Joseph Garruba
28 Winchester Dr.
Hollis, NH 03049
2/7/2020

To: Members of the Hollis Planning Board

Issues With the Proposed Development of Tax Map 41 Lots 25, 28 and 44 Including Review of Developer's **FOURTH** Alternate Roadway-2 Layout Submitted on 1-28-2021

Figure 1. Developer's Submitted Alternate Roadway-2 Plan Sht. CN1 Received on 1/28/2021 Enlarged Showing Intersection Location

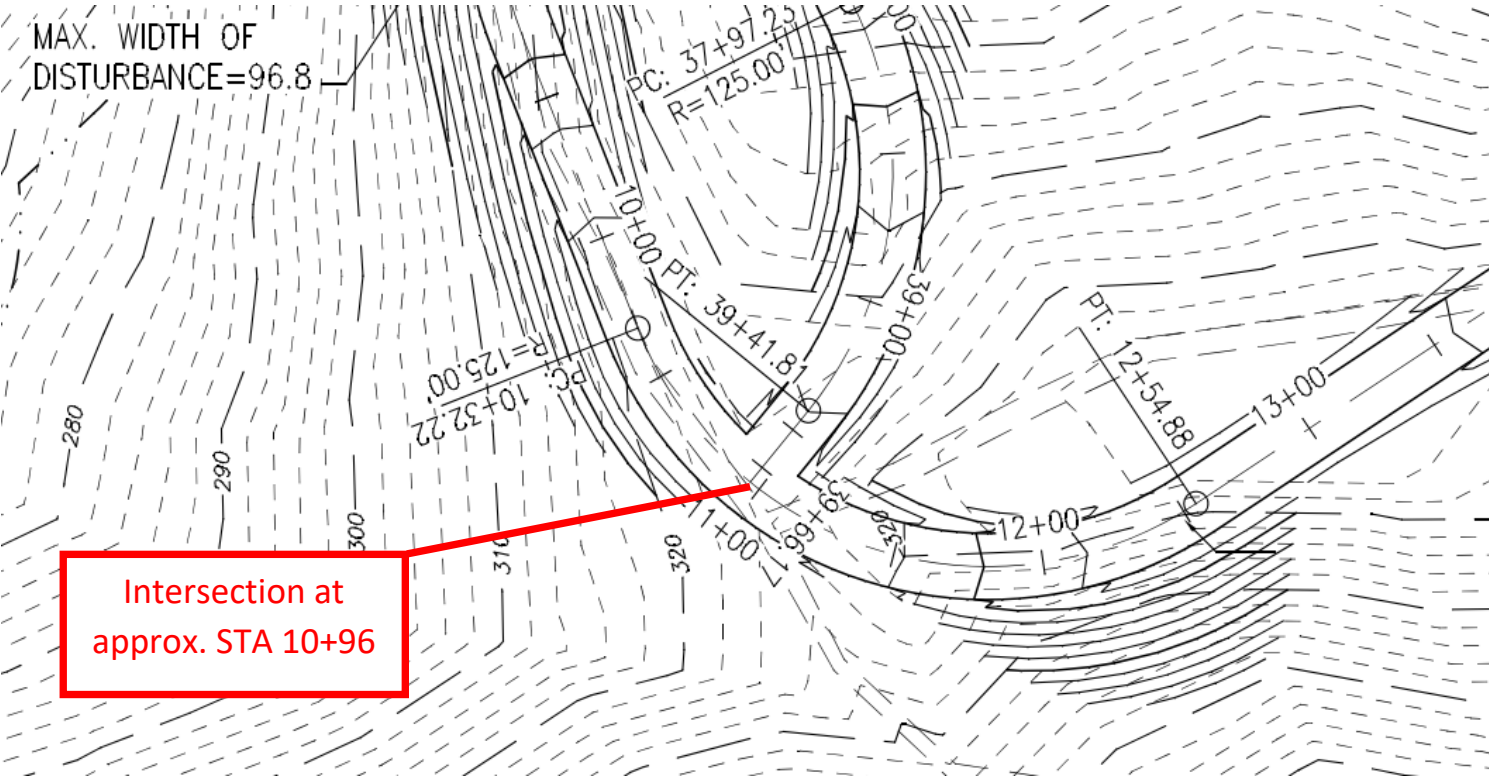
The Table of Geometric and Other Standards in section IV.7 E of the Hollis Subdivision Regulations, partially included for reference below and rectangles added for emphasis, requires that roadway grade within 100 ft. of an intersection be 3% or less. The roadway design submitted by the developer on 1/28/2021 is not compliant between STA 10+96 and STA 11+96. The following images identify the location of the intersection and graphically prove the compliance issue.

Figure 3. Developer's Submitted Alternate Roadway-2 Plan Received on 1/28/2021 Enlarged Showing Intersection Location

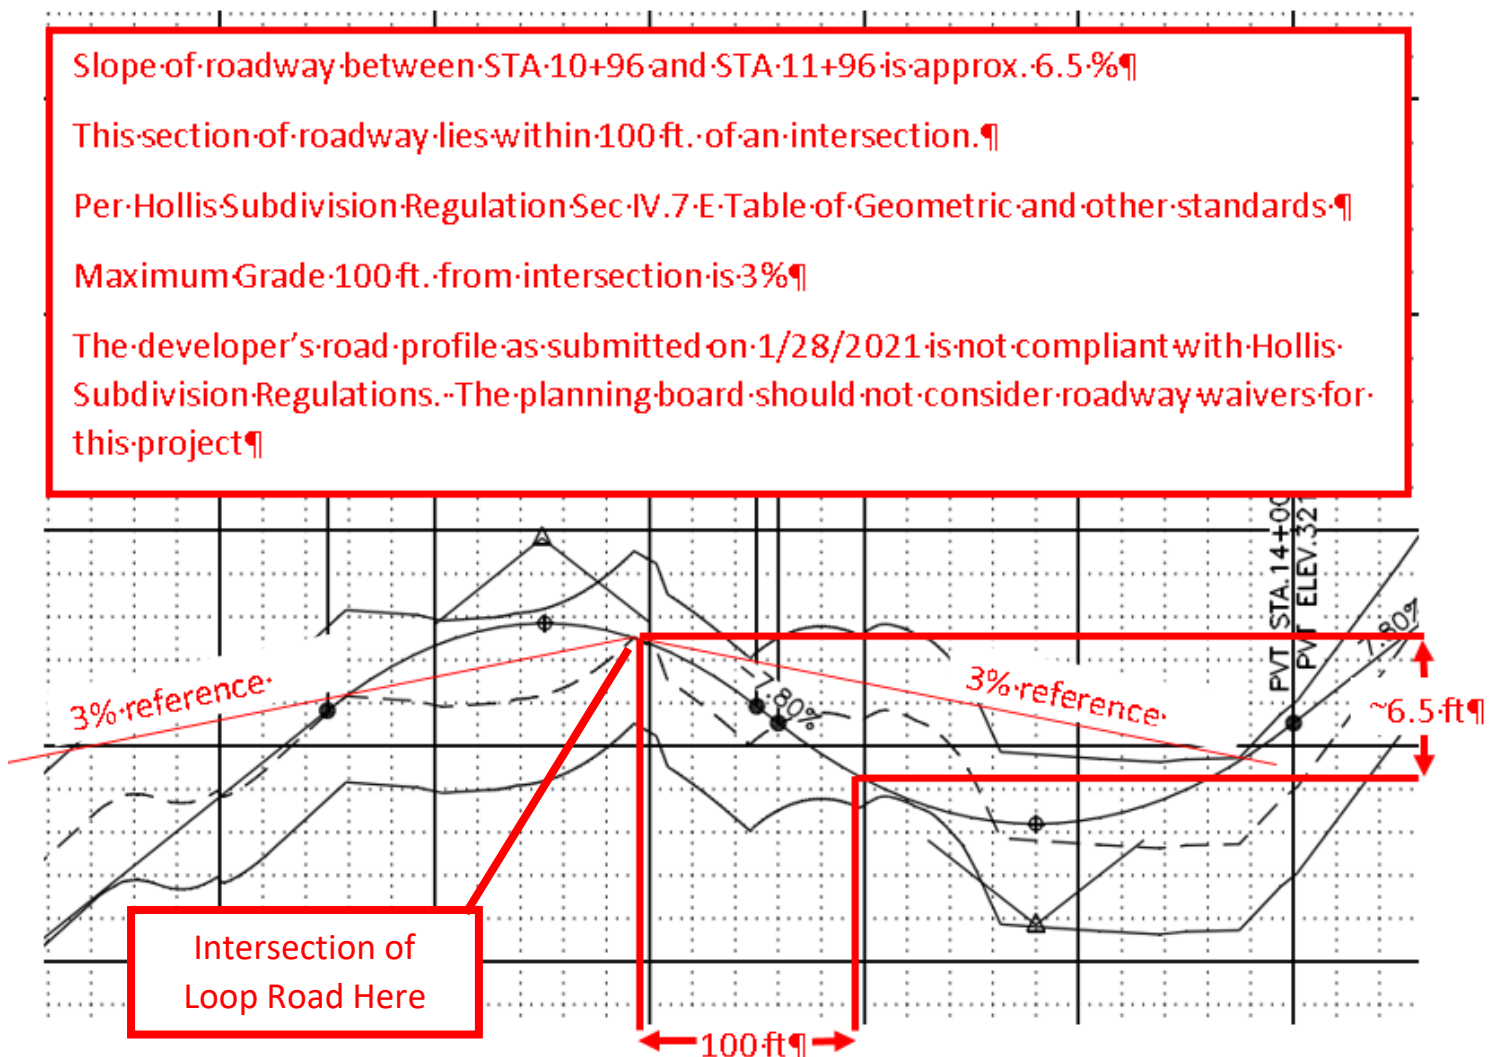
The profile above is an enlarged section of sheet 2 of the developer's submitted alternate roadway-2 plan submitted on 1/28/2021. The intersection of the loop road is located at approximately STA 10+96. It can be seen that the 100 ft. of roadway between the intersection and STA 11+96 has an approximate grade of 6.5%. This is more than two times the maximum allowable grade 100 ft. from an intersection. This is a clear violation of the Table of Geometric and Other Standards included in sec IV.7 of the Hollis Subdivision Regulations. Since this is the developer's fourth attempt to submit a compliant road, it is becoming clear that the developer cannot achieve compliance. I am requesting that the Planning Board deny this project a waiver for road construction and have the developer submit a compliant proposal. It is likely that compliance could be achieved in a design that did not include 51 buildings on top of the hill. The Planning Board should recommend a reduction in unit density.

Figure 4. NRPC Aquifer Layer Overlaid With the Subject Parcels Outlined in Yellow

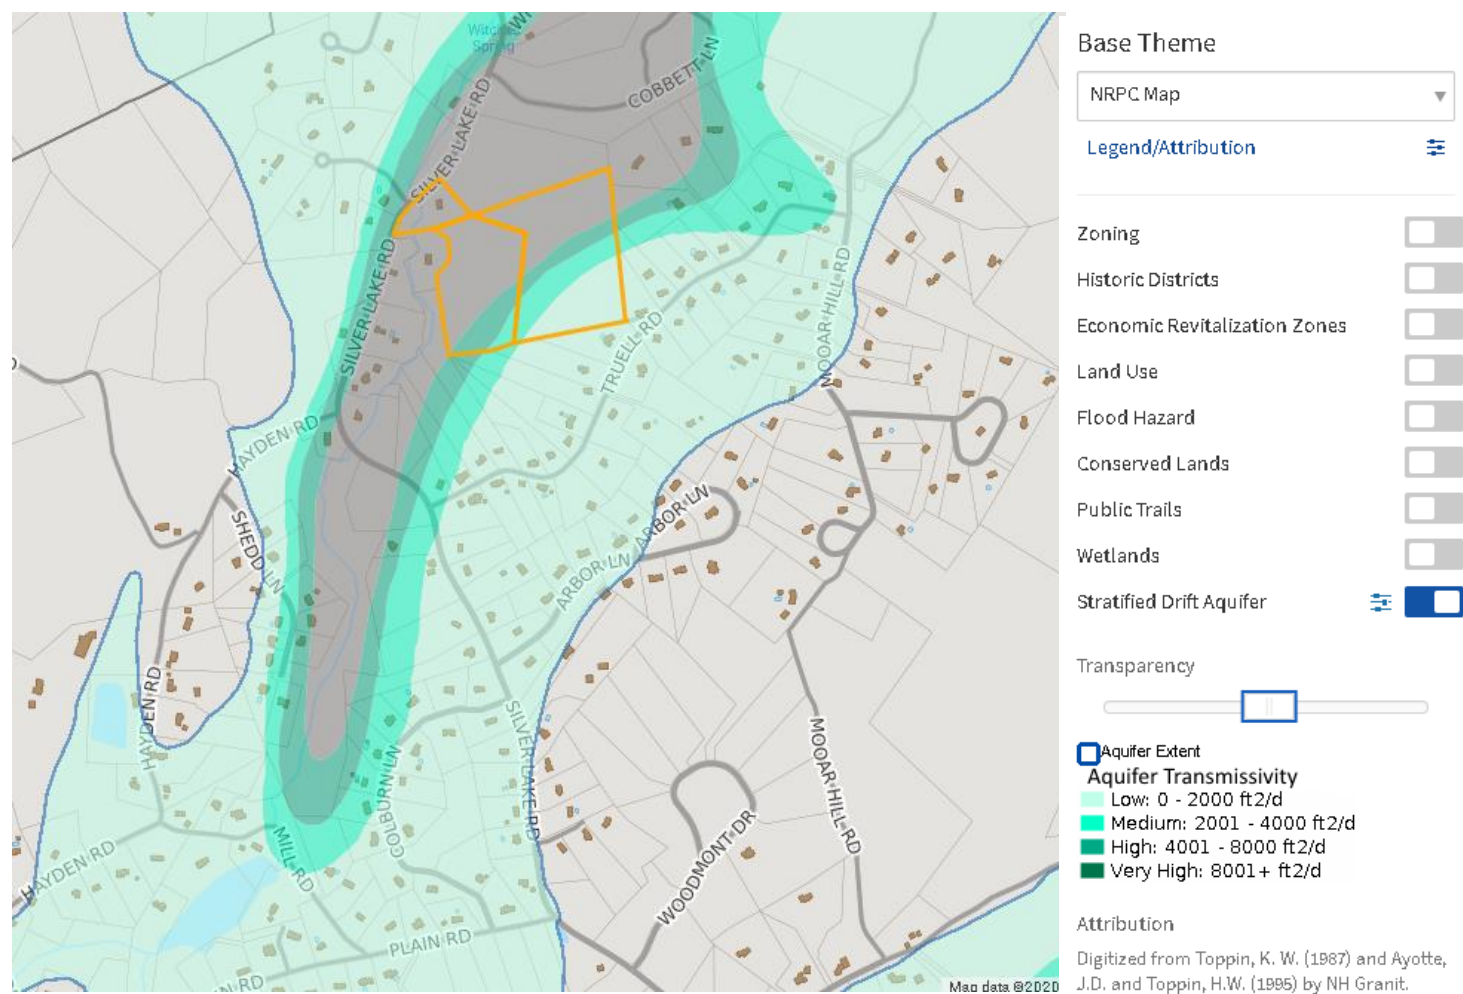
It can be seen that note 7, as provided by the developer on the plan submitted on 1/28/2021, is incorrect. A comparison of the NRPC website clearly shows that these lots are well within the Aquifer Protection Overlay Zone. The subject property is actually shown on plate 4 of USGS report 86-4358. There is a considerable amount of roadway proposed in this project. This will leave a limited amount of impervious area for buildings and parking spaces. The Aquifer Protection Overlay Zone as well as the Housing For Older Persons Overlay zone limit impervious cover to 15% of the lot area. The Planning Board should protect our aquifer by requiring the project to comply with the zoning ordinance with respect to the Aquifer Protection Overlay Zone which imposes additional environmental protections on the subject lots.

Figure 7. Cross section of Station 8 + 80 Showing Road Width Compliance Issue from Sheet 3 of the Developer's Conceptual Alternative Profile-2 Submitted on 1/28/2021

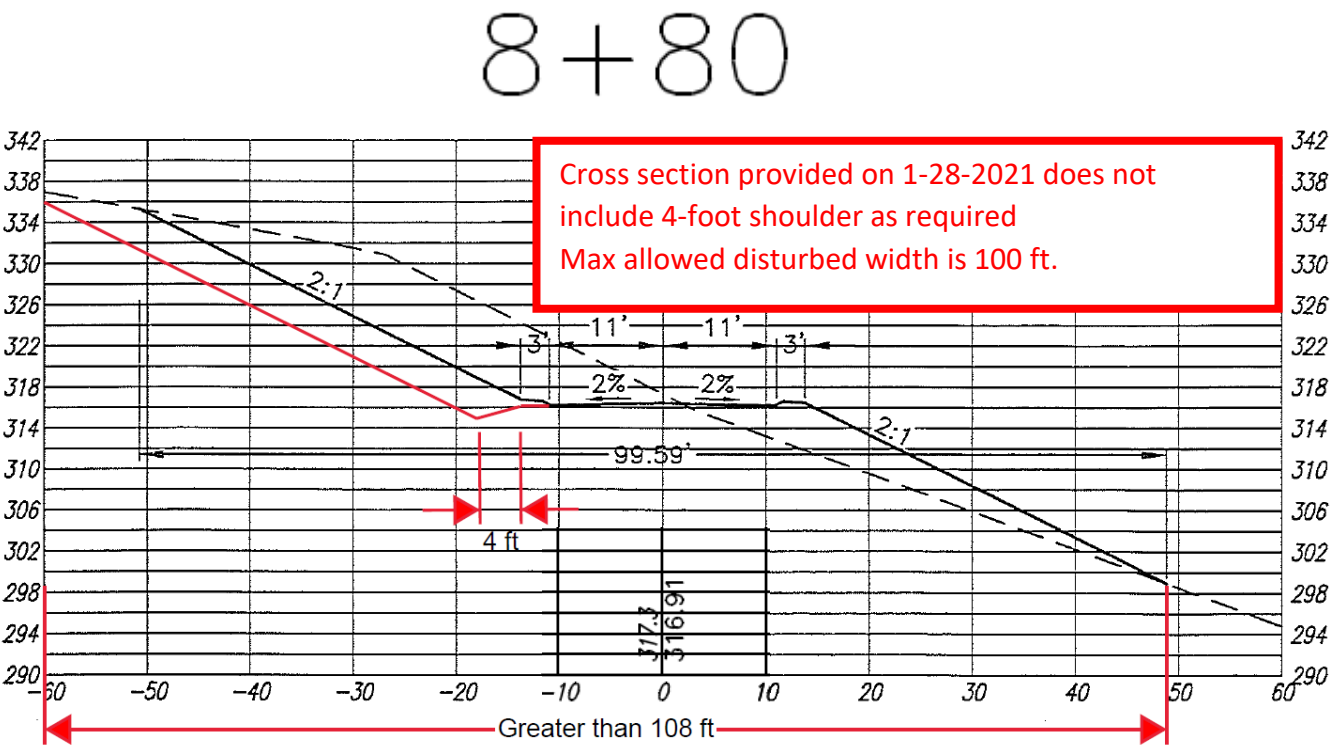
Station 8 + 80, as shown below, has been marked to show the required 4-foot shoulder and the impact that has to the disturbed width. The cross section provided by the developer does not include the required shoulder. It can be seen that the disturbed width is incorrectly depicted as 99.59 feet. However, the actual disturbed width is greater than 108 ft., when the required shoulder is included.

Figure 8. Cross Section of Station 25 + 80 Showing Road Width Compliance Issue From sheet 3 of the Developer's Conceptual Alternative Profile-2 Submitted on 1/28/2021.

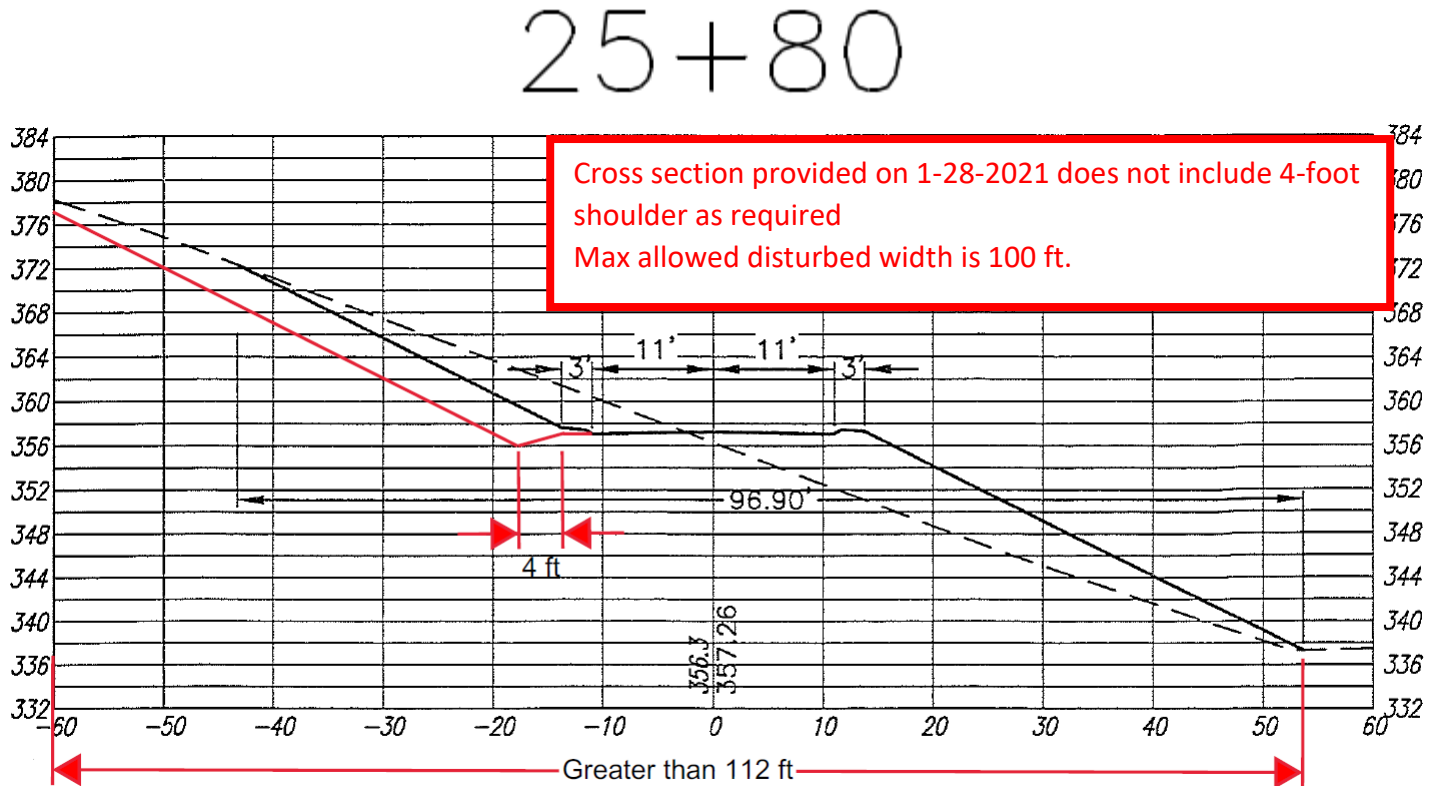
Station 25 + 80, as shown below, has been marked to show the required 4-foot shoulder and the impact that has to the disturbed width. The cross section, which the developer provided in this case, does not include the required shoulder either. It is notable that the disturbed width is incorrectly depicted as 96.9 feet, when the actual disturbed width is greater than 112 ft. and when the required shoulder is included.

Figure 11. Profile of Station 1 +00 Showing 13.4 ft. Cut From Sheet 3 of the Developer's Conceptual Alternative Profile-2 Submitted on 1/28/2021

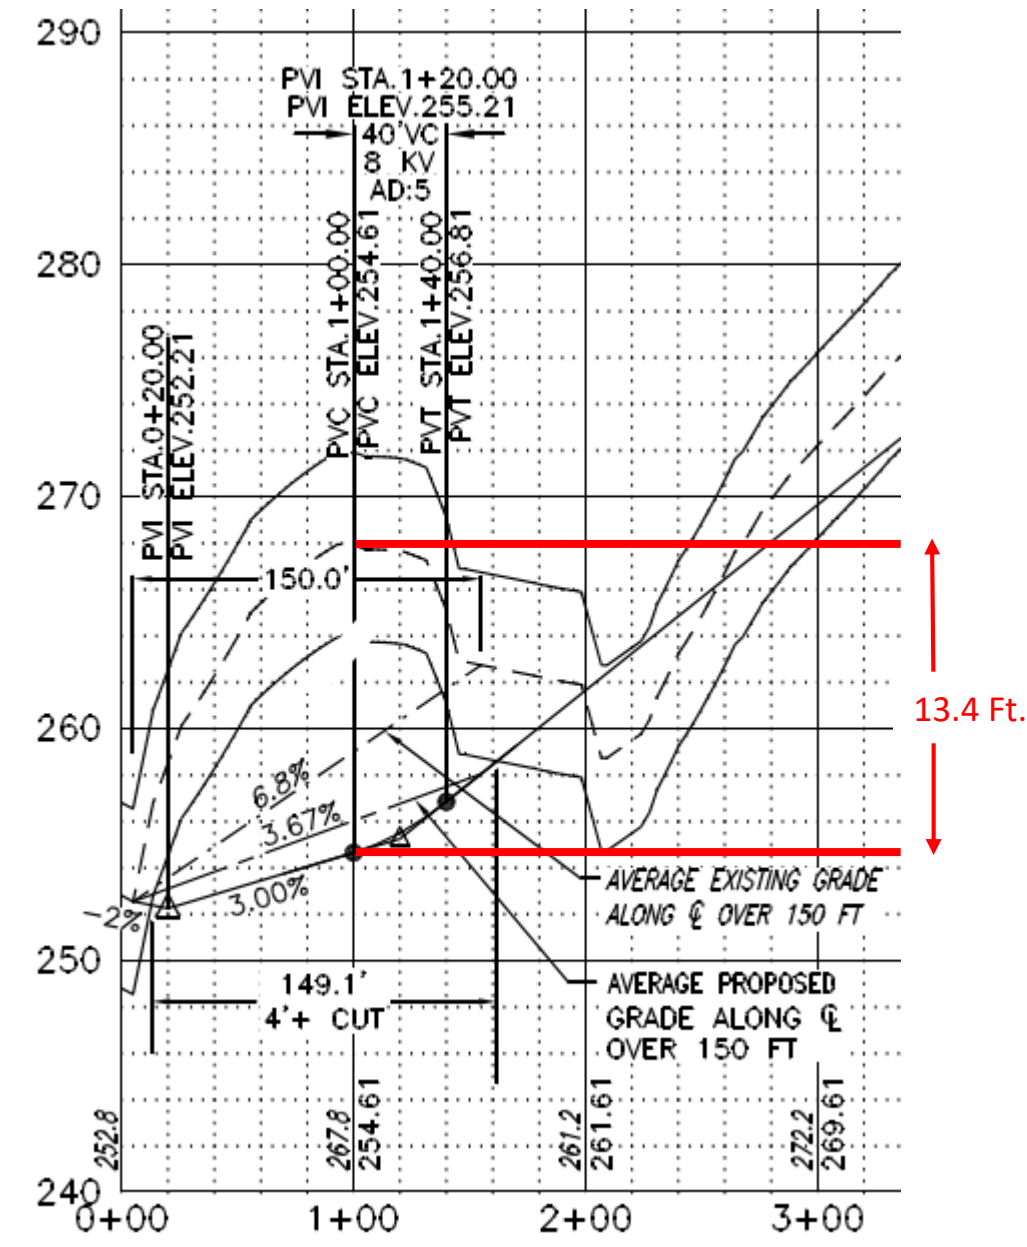
The documentation provided does identify an instance of two cuts greater than 4 ft. which are within 1000 feet of each other. There is a 13.4-foot cut at station 1+00, and there is a 7.6 ft.-cut at station 8+80. These two locations are only 780 feet apart on the roadway, and thus, they do not meet the requirement set out in Sec IV.7 of the Hollis Road regulations.

Figure 13. Road Profile to Station 10 From Sheet 2 of the Developer's Conceptual Alternative Profile-2 Submitted on 1/28/2021.

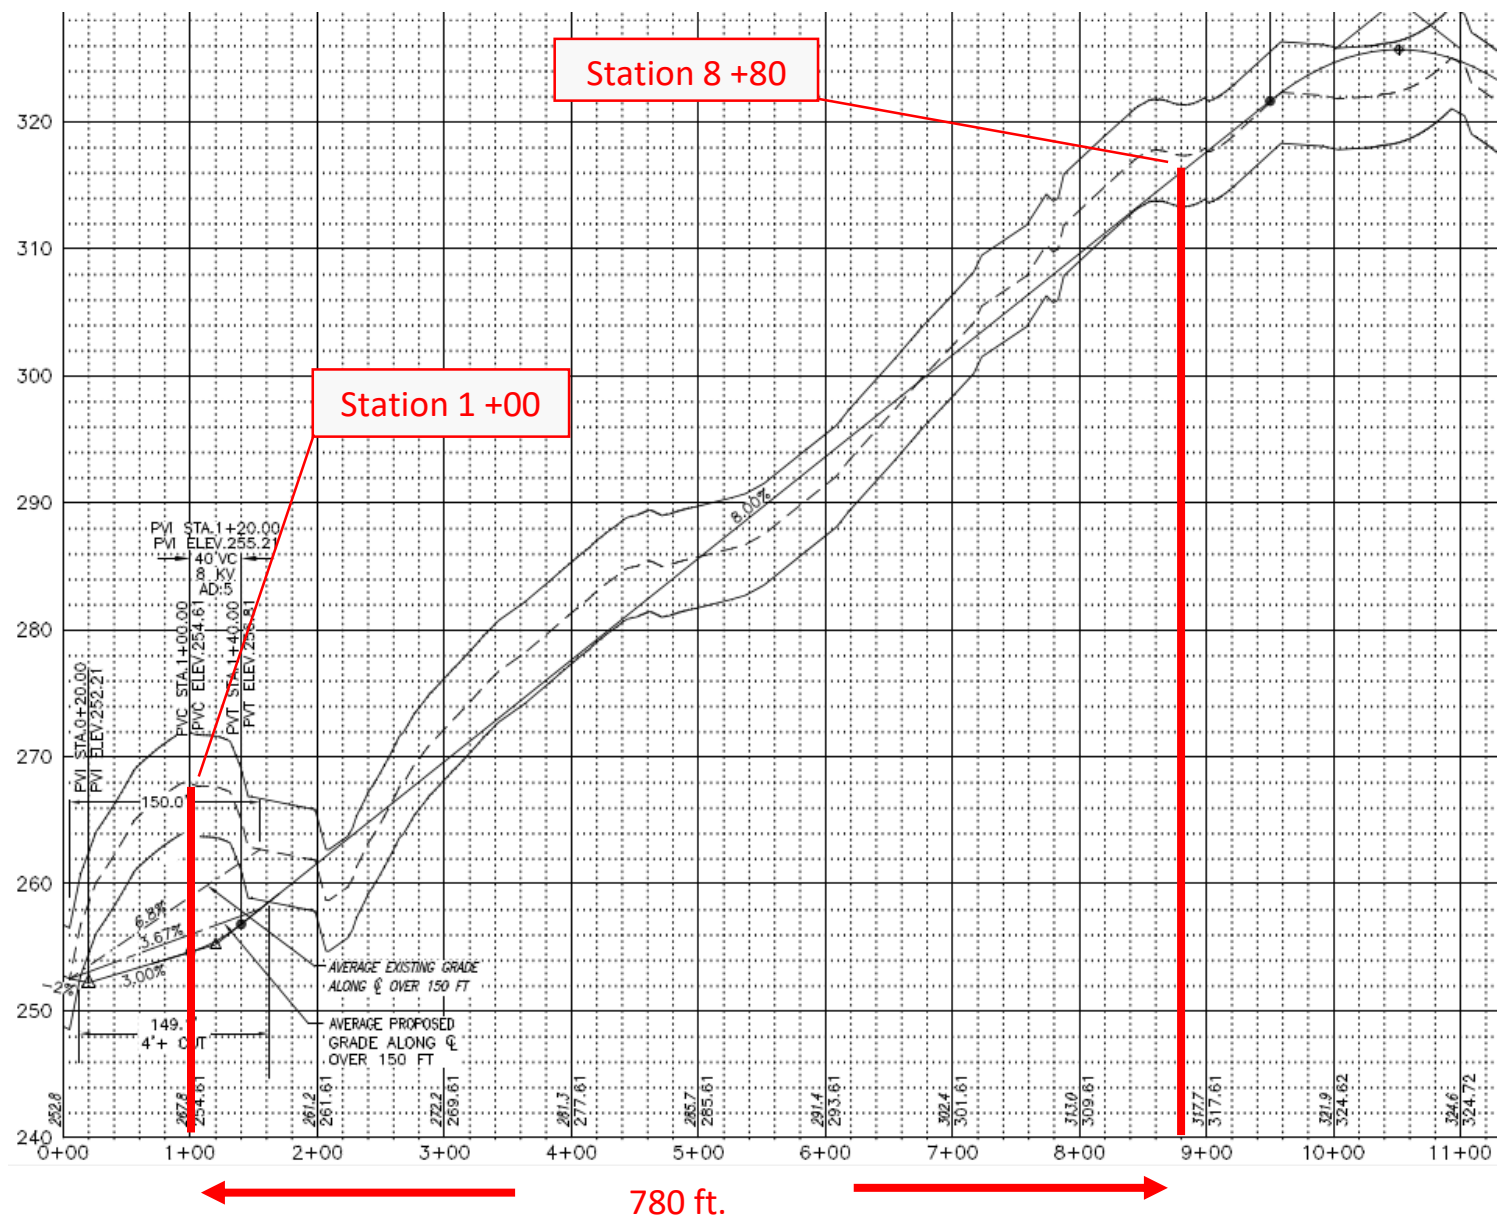
The image below highlights the location of the two cuts on the road profile provided and shows that the cuts, which are both greater than 4ft, are only 780 feet from one another.

Section IV.7 requires that cuts and fills greater than 4 ft. be limited to one occurrence per 1000 ft. The proposed road has compliance issues in many locations. Two documented ones are called out above – STA 1+0 with a 13.4-foot cut and STA 8+80 with a 7.6 ft.-cut. These locations are only separated by 780 feet, not the required 1000 ft. In addition, the cut at STA 1 + 00 continues to be greater than 4 ft., out to STA 1+60, thus reducing the distance between the cuts further to approx. 720 ft. The Planning Board must uphold the requirements as written. Clearly this proposal is not compliant.
